Model: CDS
Serial #: N/A

Product Bulletin # CDS-012 Rev 1

Replacement of Coupler Plate Mount with Brace for CDS Link Tilt Operations With Stabilizer Kit

Figure 1: Guard, Mount and Multi Coupler View

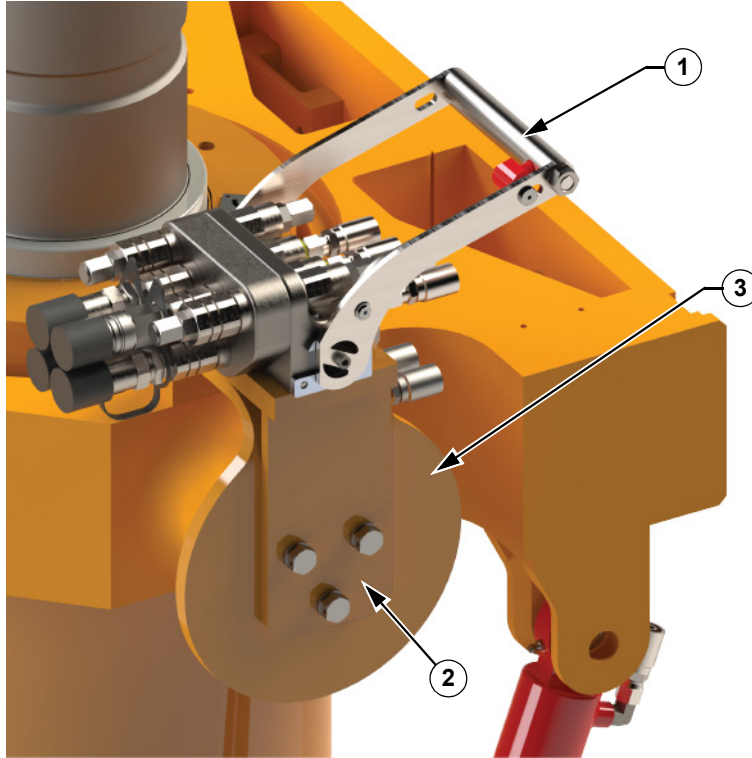
A dropped object incident occurred involving a trunnion #5104016, a component of Single Joint Links Stabilizer Kit #5104015. The Trunnion was installed with inadequate length bolts while a #DT24294 Coupler Plate Mount was also present on the CDS Link Tilt Assembly. The Coupler Plate Mount accessory #DT24294 was not taken in consideration at the time of SJ Links Stabilizer Kit design.

2. Disassemble the Multi Coupler Plate #H16763 (1), Mount #DT24294 (2) and Guard #16062 (3) from the CDS Link Tilt Assembly (ODS side only):

3. Discard the #DT24294 (2), ODS Guard #16062 (3) and their fasteners.

Figure 3: Brace installation – Top side

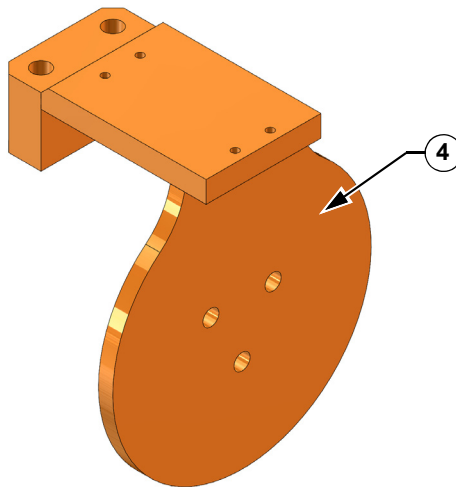
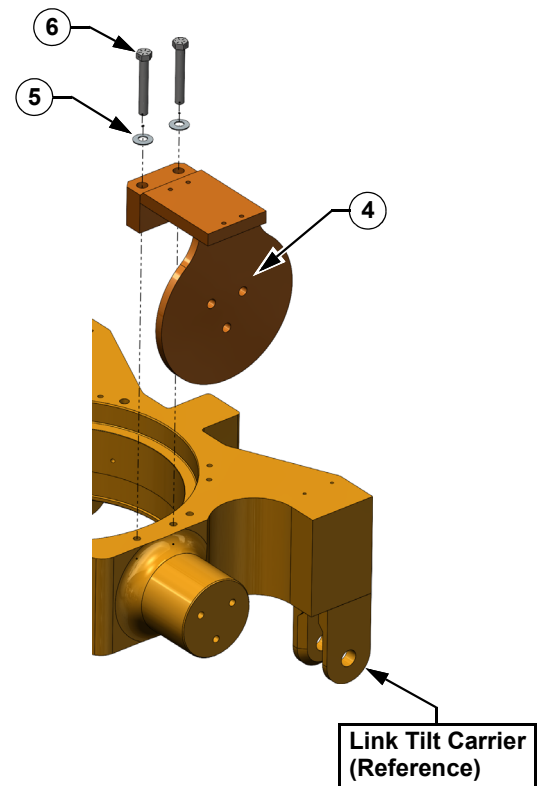
4. Install Brace #5105106 (4) with fasteners – top side only.

- 2x Washer, Lock, Helical Spring, 1/2", Alloy, Pld #5881 (5).
- 2X Screw, Cap, Hex Hd, 1/2"-13UNCx3-1/2", Gr8, Pld, Dr Hd #16327 (6).
- Apply Lock Wire.

Trunnion (7) and Fasteners (8, 9) from Stabilizer Kit #5104015 are necessary to finalize Brace's installation (Step 6 on page 4).

Figure 4: Brace, Multi Coupler and Stabilizer Kit view

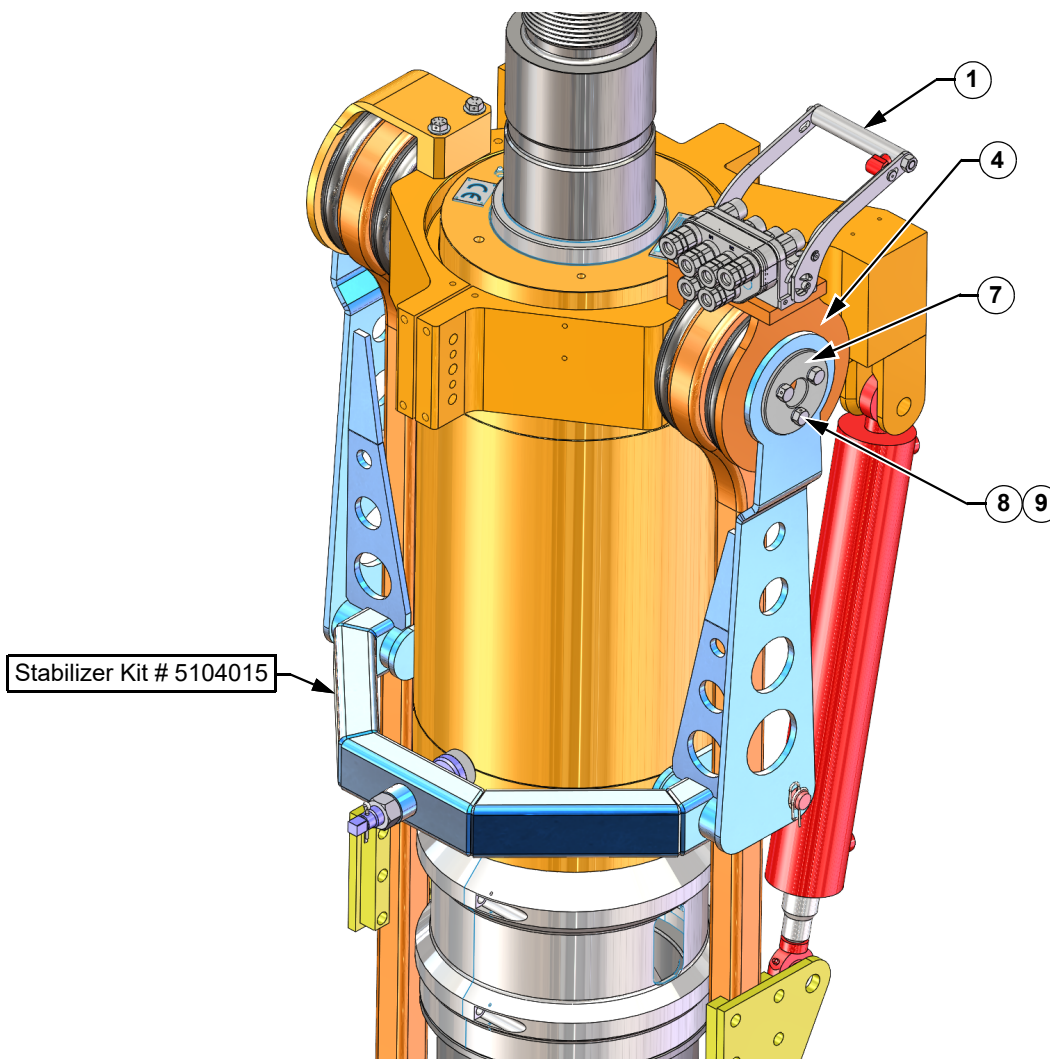
5. Install the H16763 Multi Coupler Plate (1) to the Brace (4) by re-using its fasteners:
 - 4x Lockwasher, 1/2 Nord-Lock #LW-0500-NL.
 - 4X CAPSCR, HEX SOC HD, 5/16-18UNC x 2.50, W #SH-0312NC-0250-W.
 - Apply Lock Wire.
6. Re-install Single Joints Links Stabilizer Kit to the CDS Link Tilt Assembly as per #5104015 Assembly Drawing:

Ensure the screws used to mount Trunnions #5104016 are compliant with 9012 Screw, Cap, Hex Hd, 1/2"-13UNC x 2-1/4", Gr 8, Pld, Dr Hd, torqued to 80 ft-lb and lock wired.
